## **WADE BUSINESS PARK SUBDIVISION**

*Revised for the July 20<sup>th</sup> meeting:*

APPLICATION NUMBER Holdover DATE July 20, 2006  
APPLICANT Wade Business Park Subdivision  
REQUEST Subdivision

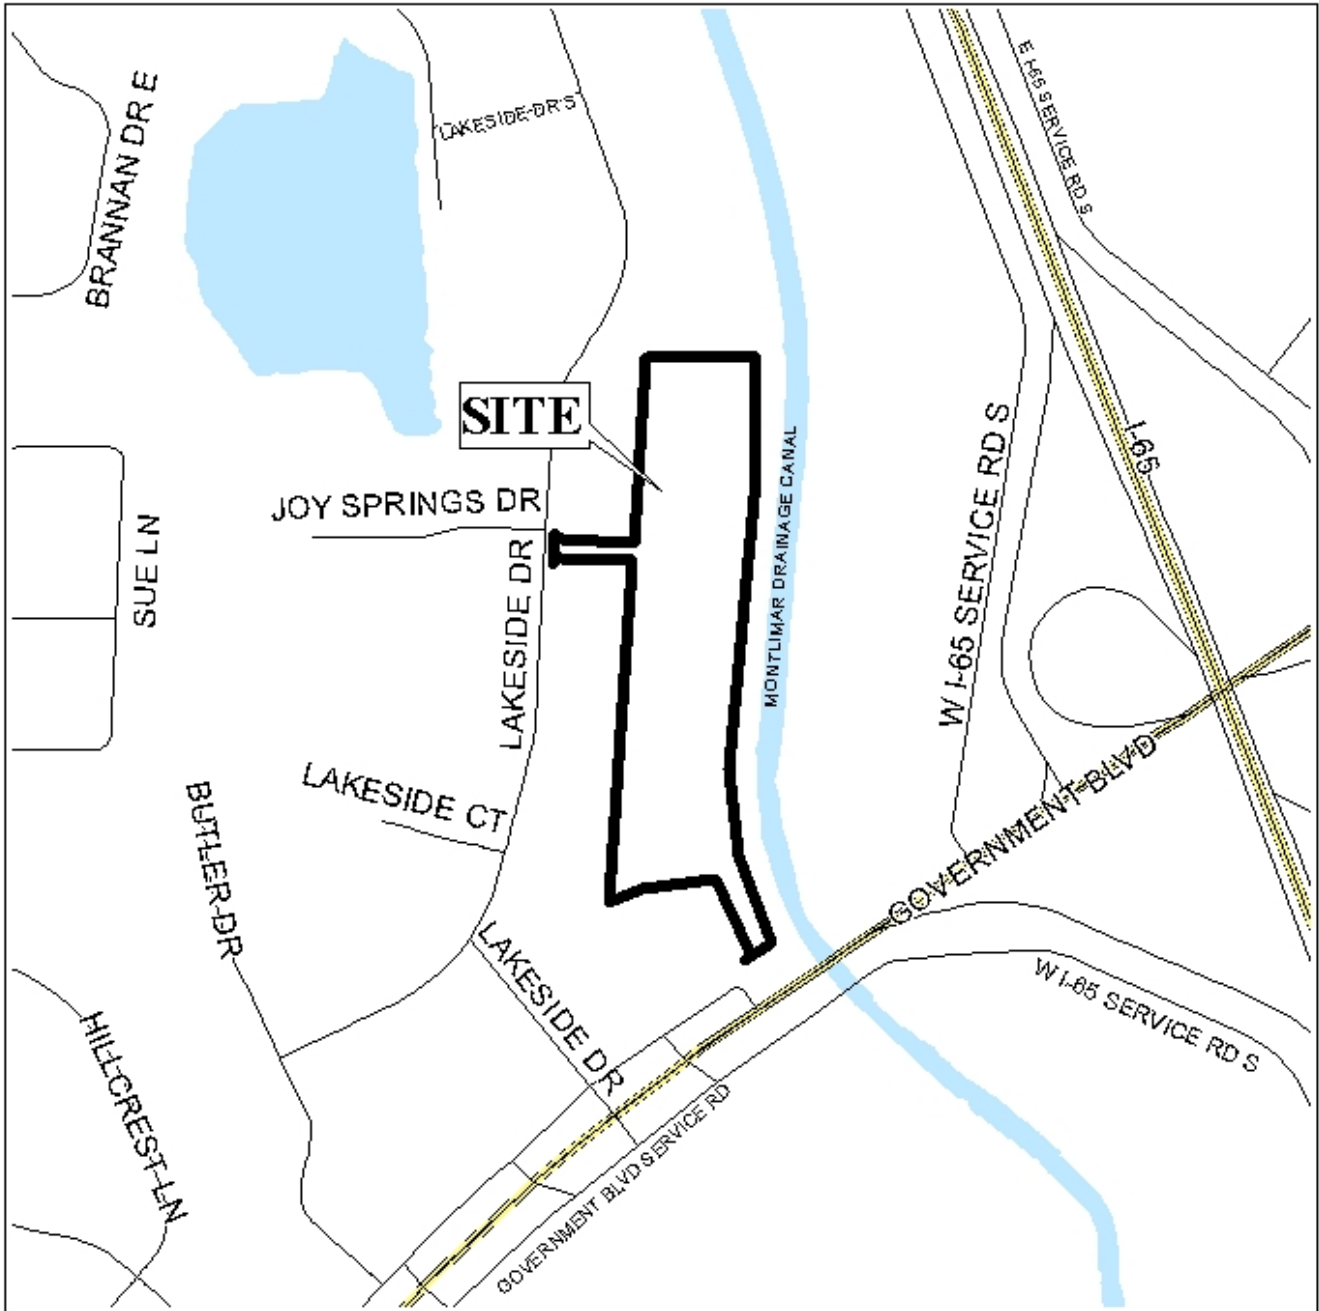
The plat illustrates the proposed 9.5± acre, four-lot subdivision, which is located at the Northwest corner of Government Boulevard and Montlimar Creek, extending to the East side of Lakeside Drive, at the East terminus of Joy Springs Drive, and is in Council District 4. The applicant indicates that the site is served by public water and sanitary sewer; these services are not required for lots of the sizes proposed, but the applicant should be aware that MAWSS could not confirm these services for the site.

The purpose of the application is to create four lots of record from a large lot of record and a smaller metes and bounds parcel. The site fronts Government Boulevard, a planned major street and U.S. Highway with a 250-foot right-of-way; Lakeside Drive, with a 50-foot right-of-way; and the Montlimar Creek drainage canal.

The site previously received approval as a 10-lot subdivision with an access road running along Montlimar Creek; however, the plat was recorded with only one lot, no street, and a "future development" area, which is here presented for subdivision. Furthermore, what is shown in the present application as two proposed "flagpole" accesses to Government Boulevard, is shown on the record plat as a "proposed street". In addition, the flagpole access to Lakeside Drive is shown on the record plat as a public right-of-way. While these access points appear to be approximately 70 feet and 100 feet wide, respectively, these measurements include the curb radii; the true width of each of these is 50 feet.

Given that the earlier subdivision approval was dependent upon the construction of streets to the site, it seems inappropriate to approve this request for flag lots.

It should also be noted that the legal description omits the length for the bearing S 02-36-00 W, which should be provided on the final plat.

Based on the preceding, this application is recommended for Holdover to the July 20<sup>th</sup> meeting, to allow the applicant to submit revised drawings showing no flag lots. Revised materials, including additional lot fees, if necessary, should be received by June 26<sup>th</sup>.

*This application was held over from the June 15<sup>th</sup> meeting to allow the applicant to submit revised drawings showing no flag lots. The applicant's representatives met with staff and explained that building roads, as originally intended, was no longer a feasible option for the developer, and that they intended to go forward with the request for flag lots. While this is the same applicant who originally created the situation by planning for roads and not building them, his representatives stated that changes in market demand and construction costs make the earlier arrangement infeasible. They noted that the principal object was the creation of Lot 2, and that Lots 3 and 4 could be combined. They were also agreeable to the idea of submitted a Planned Unit Development application to allow shared driveways.*

*Following this meeting, Urban Development staff met with Fire Department staff to determine whether flag lots could be acceptable as proposed. Fire Department staff noted that there would be requirements for hydrants and related 20 to 26-foot-wide paved fire apparatus access roads within 400 to 600 feet of all parts of each building, measured as a truck would drive. Given the length of the "flagpoles", from 173 to over 500 feet, this requirement by itself seems to mandate the construction of streets. (it should be noted that this is different from the typical flag lot request since it is both commercial and within the City; hence a different standard applies.)*

*While flag lots have occasionally been allowed in extraordinary circumstances, the constraints in this situation appear to be self-made, and it does not seem that these commercial lots in the City can meet the requirements of the Fire Code without construction of streets.*

*Based on the preceding, this application is recommended for Denial.*
